Cross is repaired for a 16" tall a 1 1/2" wide cut out of web as shown.

to drawing MCHSR49) 06297015 for plates and data not given here.

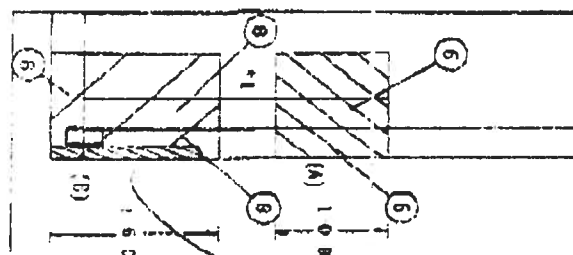
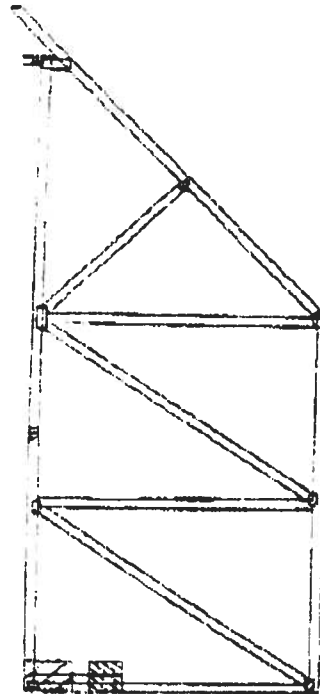
12 (1) 274 U 62 US OFFICE 2 8 8 TAI: FIELD INSTALLED REPAIR
TO BE ADDED AS SHOWN IN THE PLAN OF ISS.

1 1 1/2 WDB & 16" IALL
NOTCH CUT OUT OF STE

cross and any supported spans in proper position
rail is being made.
